General Comments

Scientific/Technical Questions/Comments/Issues

Figure 1: $Z_1 = 0 \Omega$ (short circuit) and $Z_2 = 1e6 \Omega$ (open end), $\sigma_g = 10^{-5} S/m$, $d = 10$ cm, $\epsilon_{rd} = 3$, $\epsilon_{rg} = 10$.

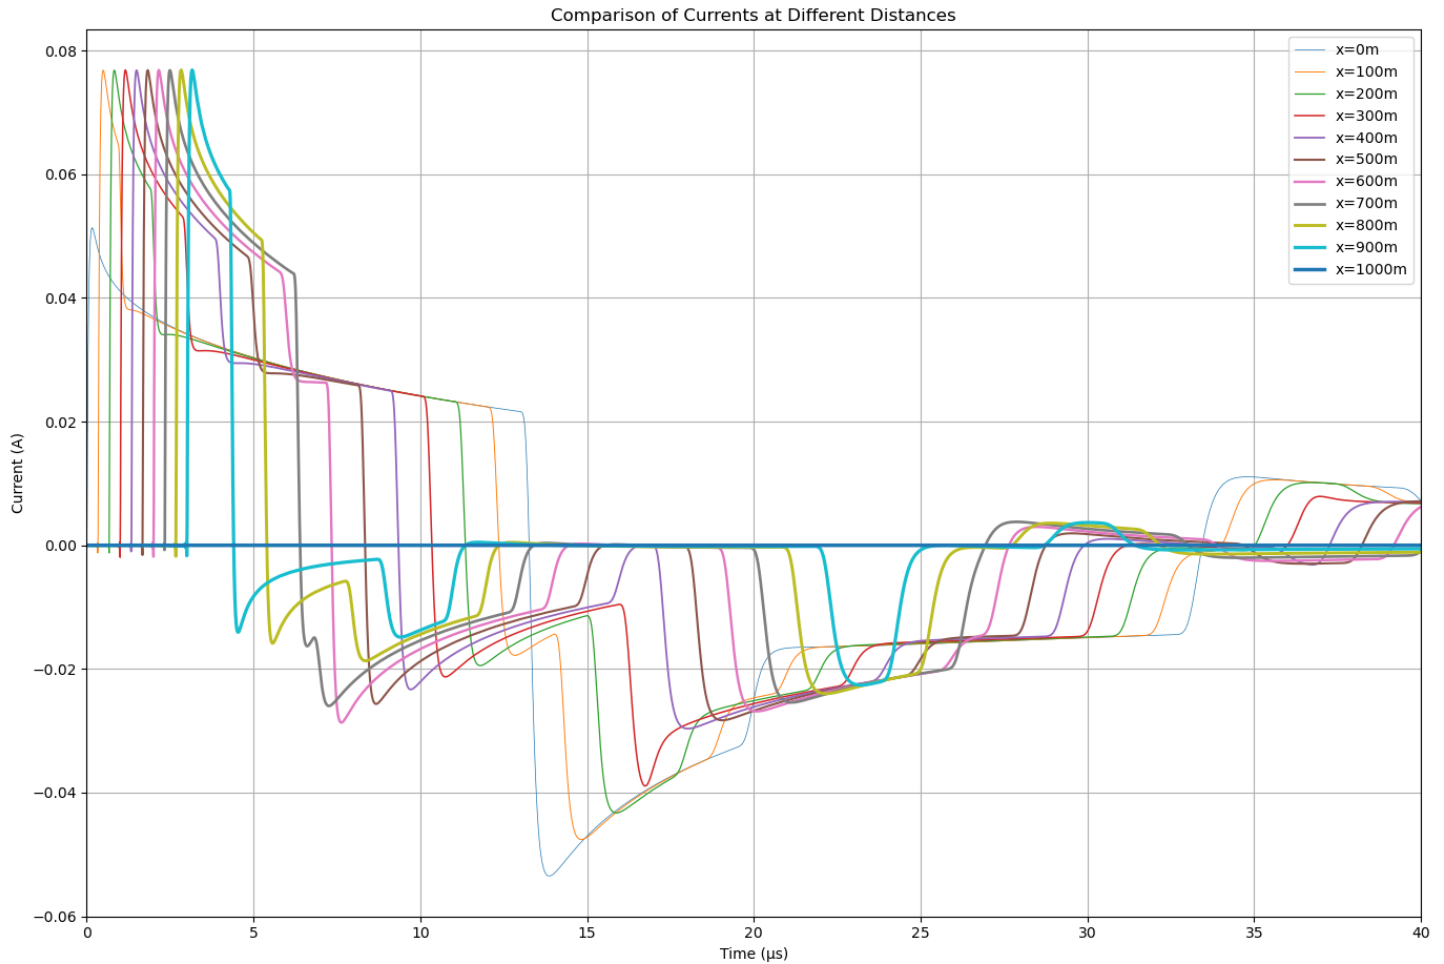
6. I am confused about Fig. 11, although I may have figured out some of the issues. In both panels in Fig. 11, the legends say “L = nnn”, but I think that it should be “x = nnn”. If these are really positions along the line, then it should be stated in the caption or the body of the manuscript. Also, the text states that the peak current at the line end in Fig. 11(a) is 82 mA, but it looks like 100 mA. For both Fig. 11 a & b, I am unable to reconcile the 15-20 microsecond periodicity in the current waveforms. Why does this periodicity exist for the cable grounded at both ends (11a)? This period also seems quite long, given that the round-trip time to one end and back, at the speed of light, is about 3 microseconds. A discussion of this would be helpful.

Thank you for the important input and the questions – the legend naming was indeed confusing and should read x=... which was corrected in the revised version, and the figure caption was adapted to “Shield currents of an insulated cable of 450 m length at various locations x responding to a distant (100 km) lightning-incident field, as shown in Fig. 7 for $\sigma_p = 10 \cdot 10^{-3}$ S/m, $\sigma_{loc} = 10 \cdot 10^{-3}$ S/m. Burial depth $d = 1$ m.”. The peak current value of 82 mA at the line end was a remnant of a previous graph generated with a different set of parameters and was not updated to match the new graphs. Thank you for catching this! Regarding the second question, how the significant changes in the current waveform and the periodicities, it is important to highlight that the propagation speed is not the speed of light but rather the velocity of an EM field propagating in the ground with a relative permittivity of $\epsilon_{rg}=10$, i.e.,

approximately $c_0/\sqrt{10}$ which is about one third of the speed of light. This velocity is further reduced by the dielectric properties of the insulation (cable jacket), with higher relative permittivity causing greater reduction. As reported by Bridges, 1992, the wave vector k , and thus the velocity, is further perturbed by losses, i.e., with changing electric ground conductivity σ_g . When interpreting the propagating fields, two factors must be considered: (1) This effective propagation velocity, and (2), depending on the line length, the frequency content of the impinging field (sharp versus smooth transient fields). Under certain conditions, the superposition of forward- and backward-travelling wave components may become difficult to distinguish in the resulting waveform, in particular when attenuation due to losses cause significant dispersion.

We can demonstrate this in this document by presenting a plot for a very sharp transient (with sub-microsecond risetime) illuminating a cable that is located close to the surface (10 cm below ground), in a very low conductivity soil ($\sigma_g = 10^{-5} S/m$). In this case, current dispersion during propagation is minimal (see Figure 1). Further, to highlight reflection phenomena, the line length is chosen to be $L = 1000$ m, terminated by $Z_1 = 0 \Omega$ (short circuit) and $Z_2 = 1e6 \Omega$ (open circuit). The current profile is sampled every 100 m. Under these conditions, the effects of the two traveling waves (forward and backward) and their reflections can be clearly distinguished in the current waveforms at different distances. For the simulation results shown in Fig. 11, such distinction is no longer possible due to the longer risetime, the chosen ground and line parameters, and the resulting dispersion/attenuation. Nevertheless, some reflection effects of the main travelling wave(s) are still visible in Fig. 11, for example, at about $10 \mu s$ at $x=450$ m, where the current drops from 90 mA to 40 mA.

Figure 2: Code validation for the computation of field-to-transmission line coupling. Top graph: reproduces the results of the bottom graph (Tesché for 10^{-5} S/m)

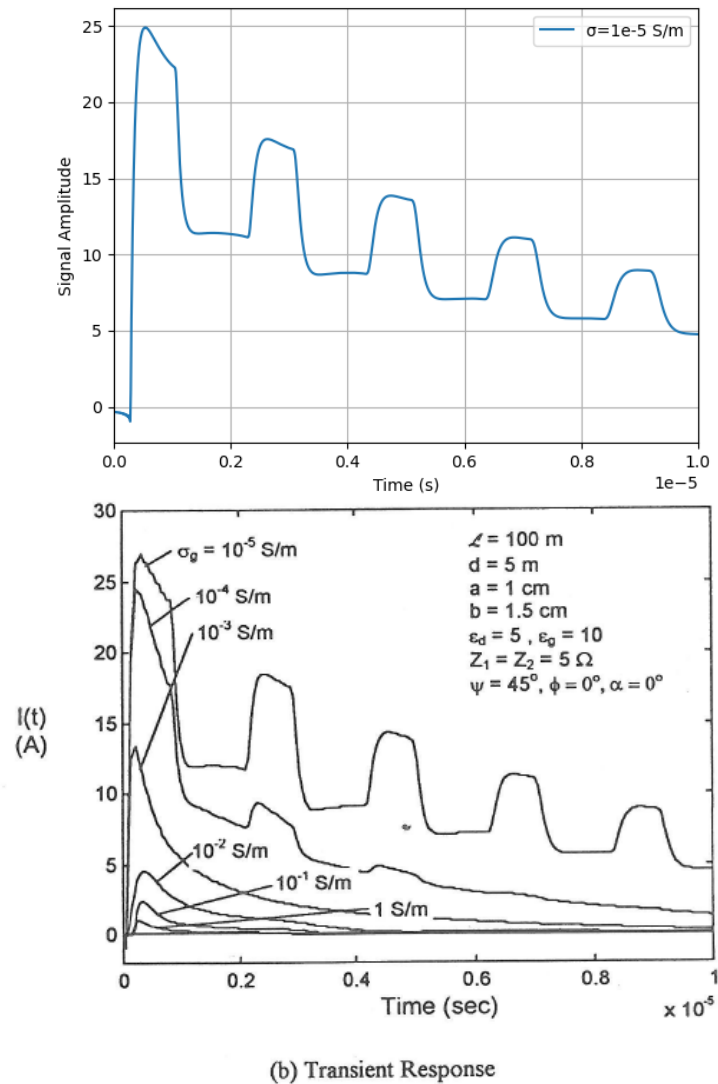
8. Figures 17 & 18 are very nice illustrations, but the parameter domains may not be ideal. The “short” risetime associated with 0.001 S/m does not provide the likely subsequent stroke risetimes seen at 100-200 km, and the “long” risetime case seems unrealistic. Also, inclusion of 0.00001 S/m in the domain for the local conductivity is probably unnecessary, and produces unstable behaviors.

All the fields were computed assuming typical subsequent RS waveform shown in Fig. 4, which is frequently employed in the literature. The “short rise time case” of Fig. 17 associated with 0.001 S/m (i.e., about $4 \mu\text{s}$) equals approximately the *median* rise time that the sensors measure in Austria for subsequent RSs. In general, we see little difference between subsequent RSs (median $5.3 \mu\text{s}$) and first RSs (median $6.2 \mu\text{s}$). The “case-study” sensor in Finland, whose site error was reproduced, even exhibits a median rise time of $8\text{-}9 \mu\text{s}$, as stated in the caption of Fig. 19. Thus, the two risetime cases investigated in Fig. 17 and 18 align well with empirical data. The inclusion of 10^{-5} S/m covers environments where rocky terrain dominates the sensor’s, a scenario once observed in Mallorca, where a mountaintop sensor exhibited $\pm 40^\circ$ site errors. In that case, numerous metallic structures surrounded the sensor. Further, the authors do not think that instability is an issue. The purpose of Fig. 9 was to show that the computational codes that evaluate the ground penetration yield correct results (validation by means of FDTD simulations). The coupling code itself is also stable and was tested against the results from Tesche et al.’s book: EMC Analysis Methods and Computational Models, Chapter 8.6. It faithfully reproduces the currents for the case of 10^{-5} S/m and a 100 m long line, see Figure 2.
